Subject: Change Oder 005- Midway Branch Force Main Conflicts and other Scope Modifications

Change Order 005-Midway Branch Force Main Delays

Change Order No. 05
Corporate Dr Segments 4&5
Project No. G1124 &G1125

SHEET
249
OF
328

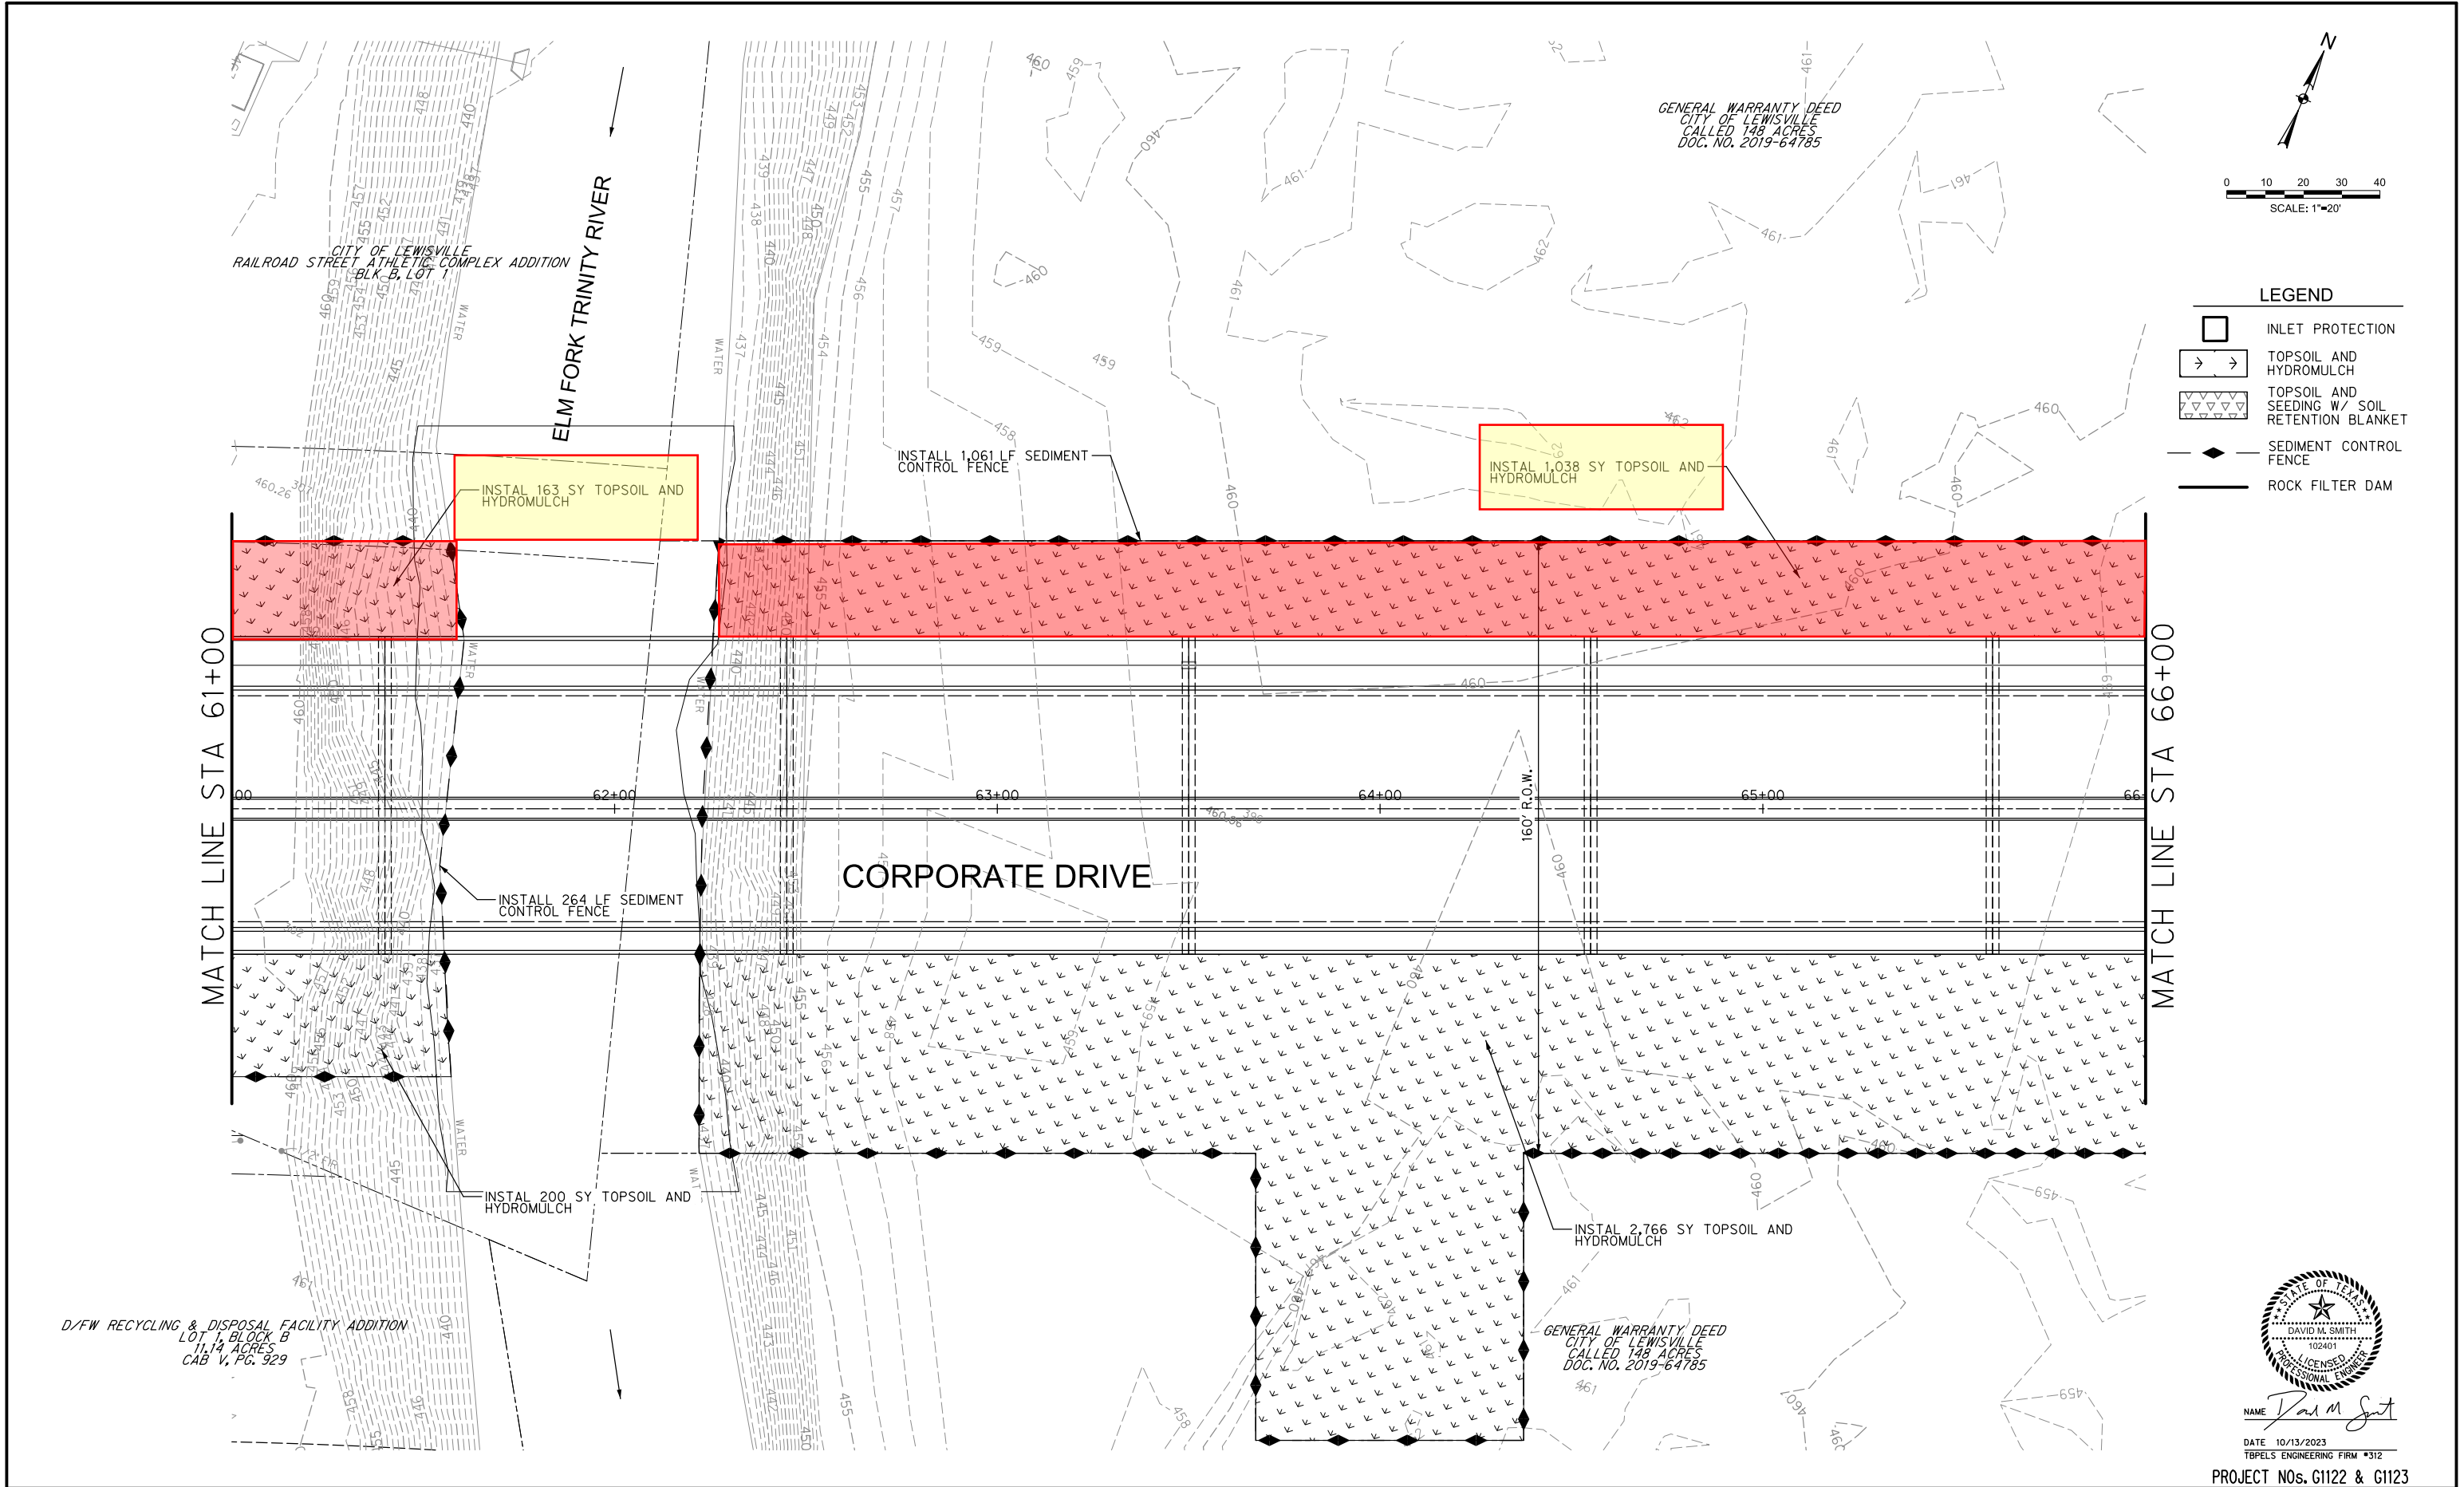
Quantities below represent what will be delayed due to
the Midway Branch Force Main

Seeding w/ Retention Blanket	9,954.00	SY
Topsoil and Hydro Mulch	5,812.00	SY

**DELAYED SIDEWALK INSTALLATION
DUE TO MIDWAY BRANCH FORCE MAIN
INSTALLATION**

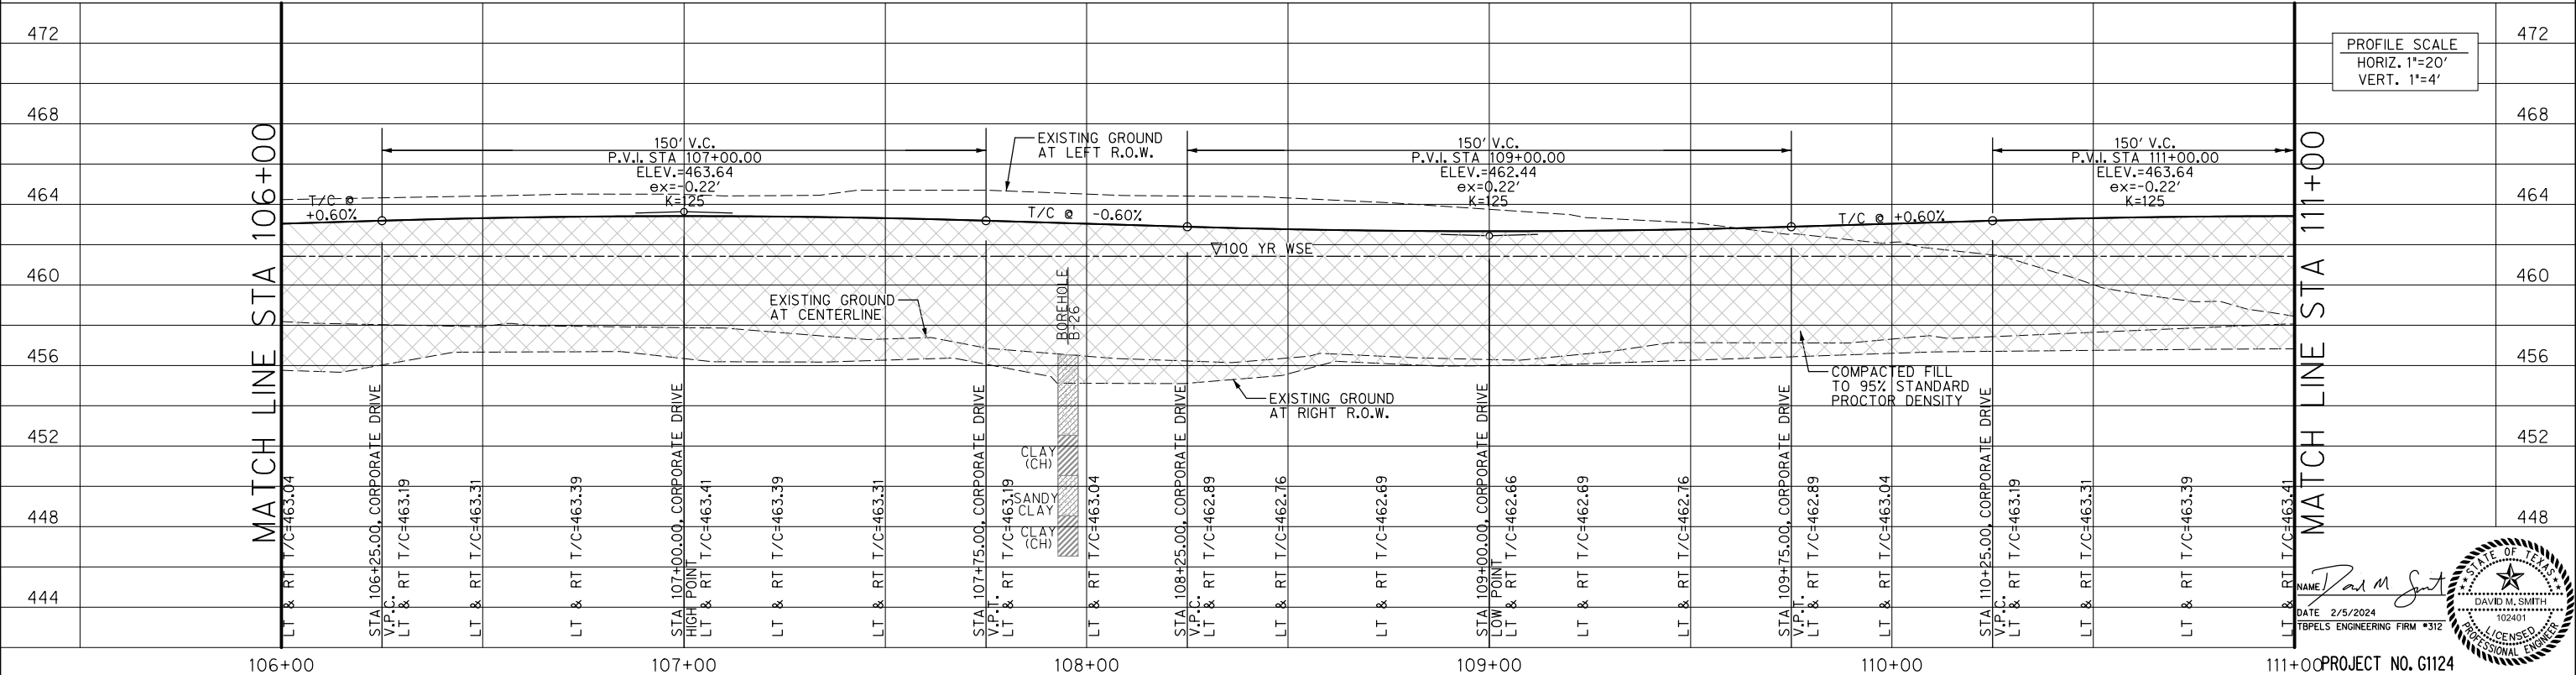
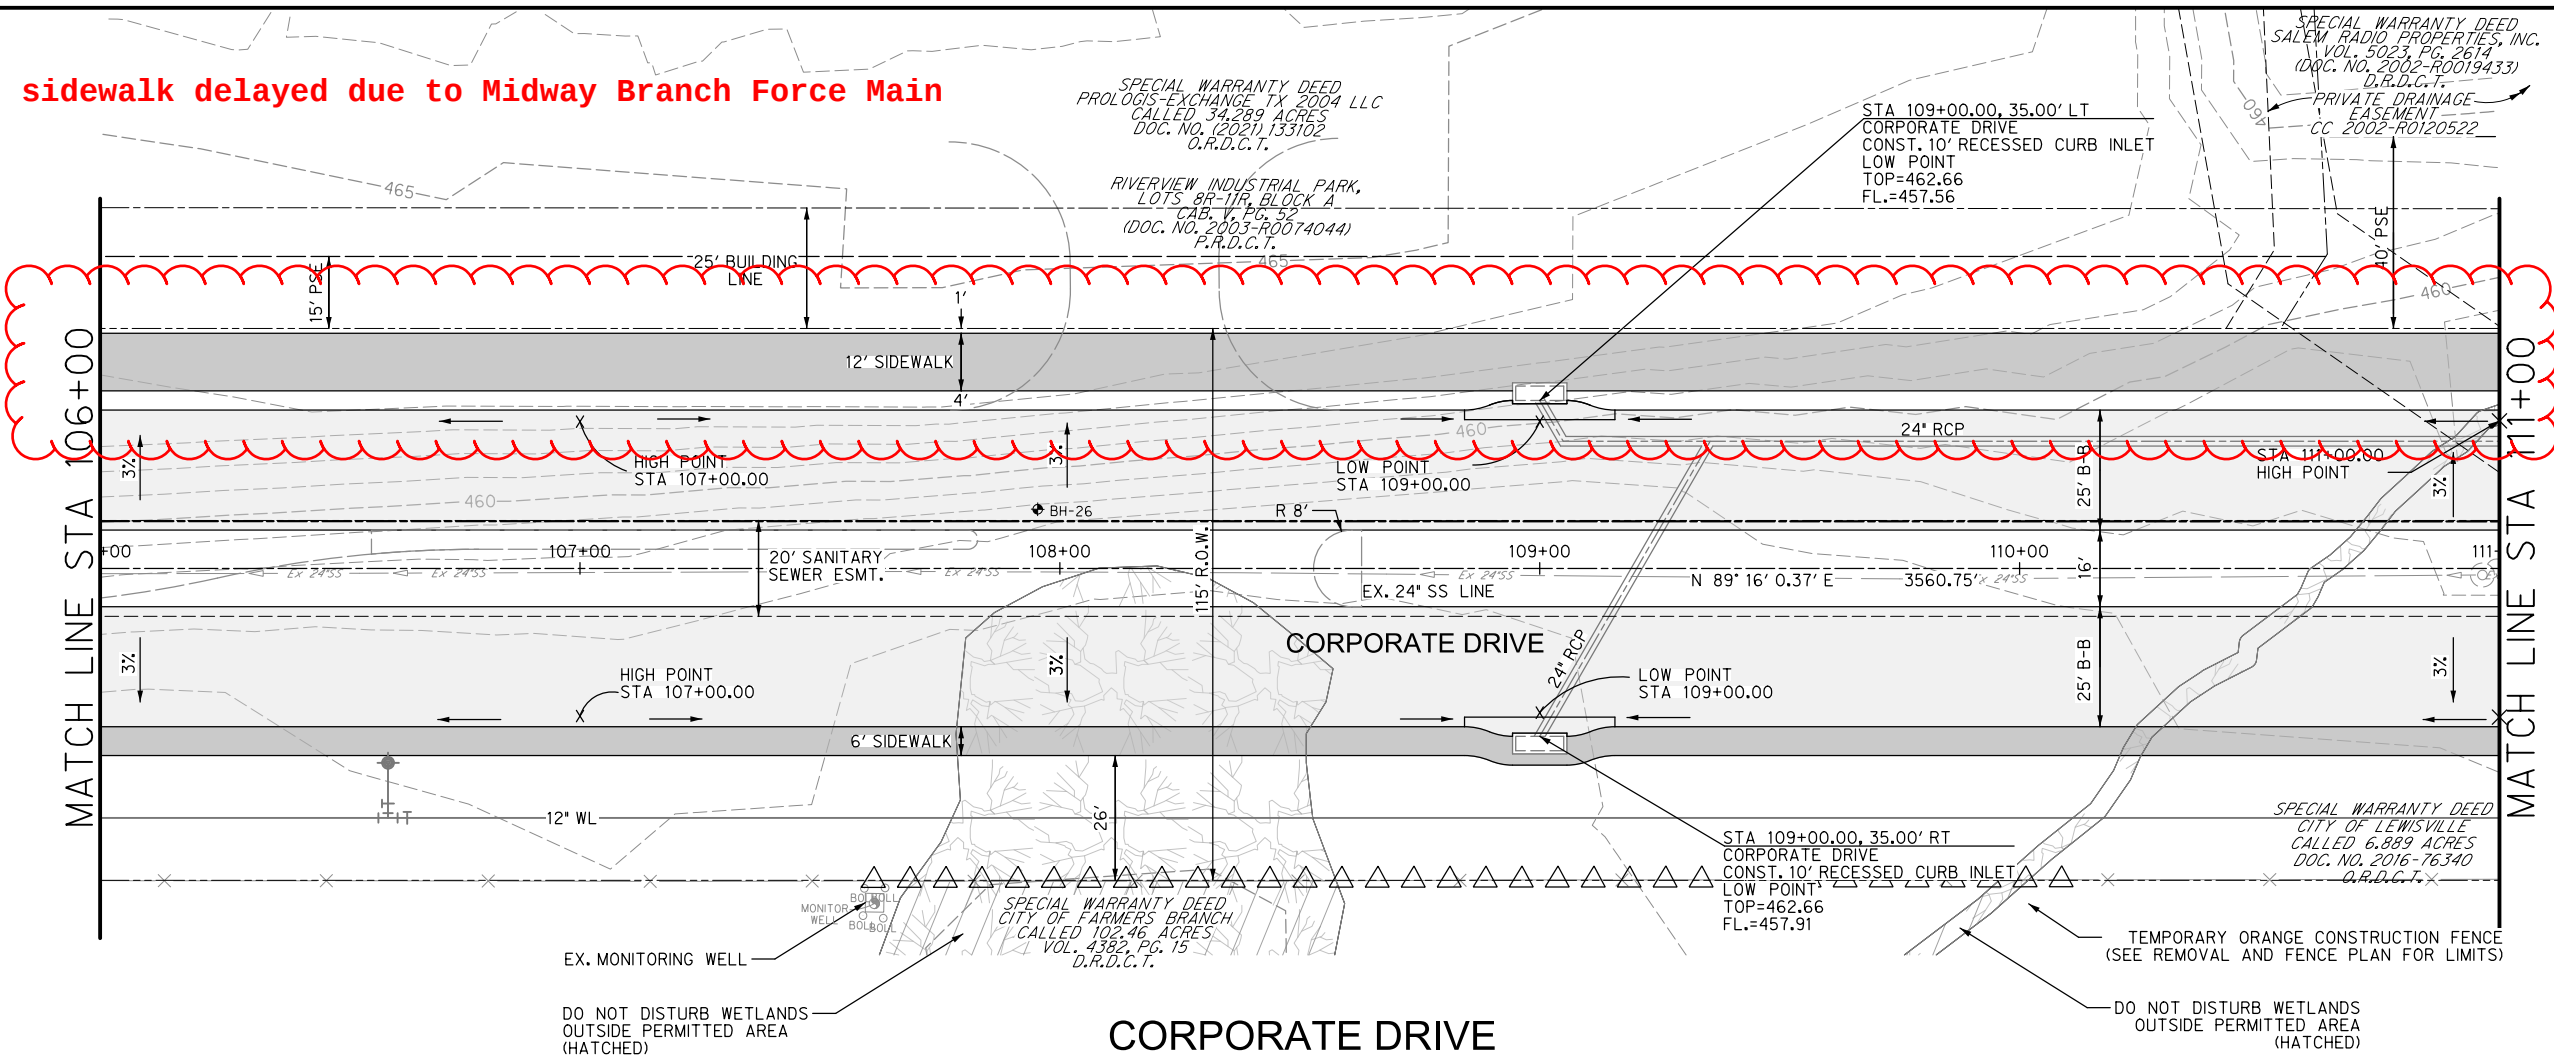
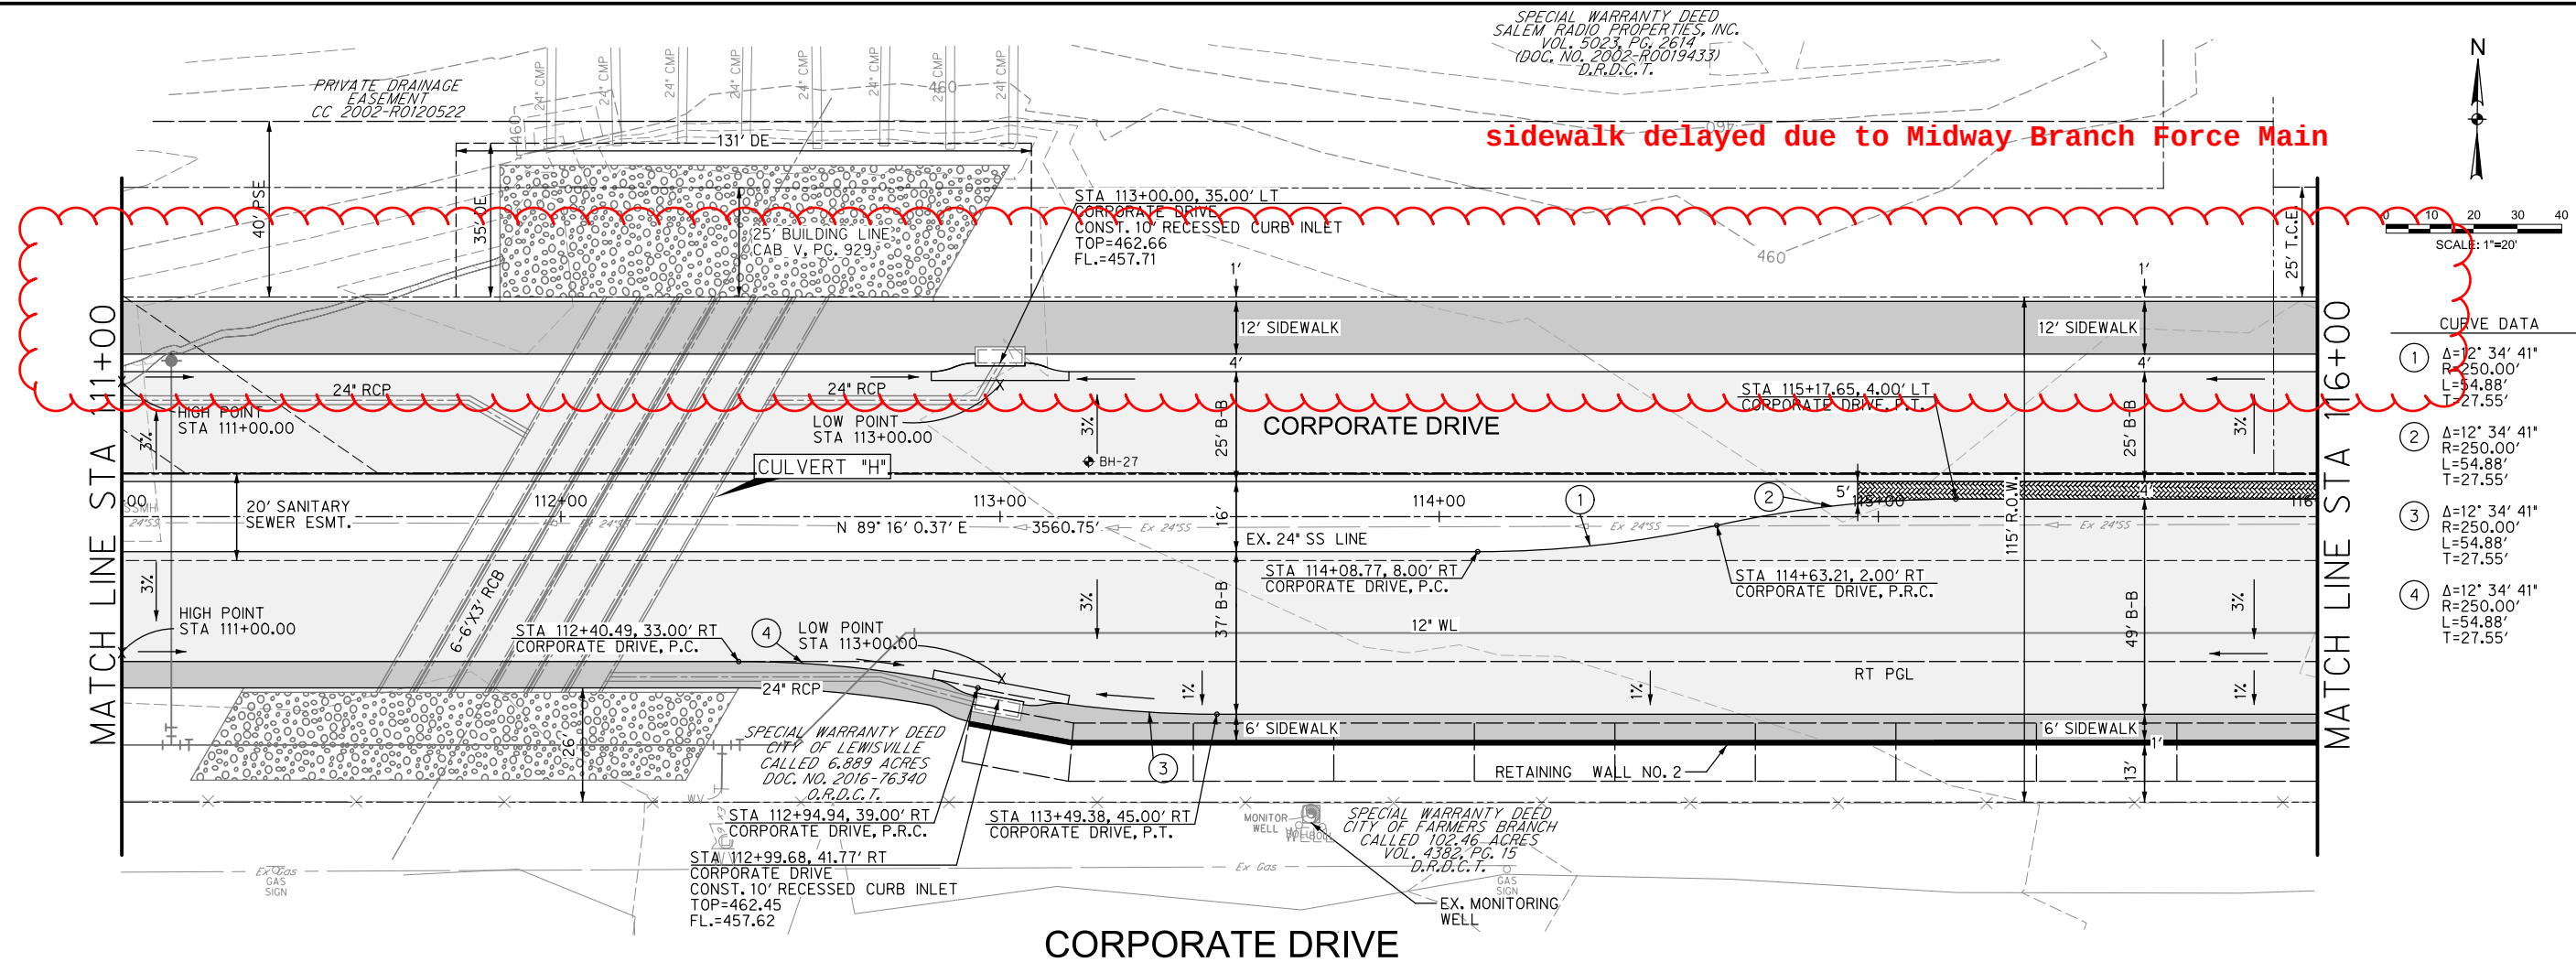
sidewalk delayed due to Midway Branch Force Main
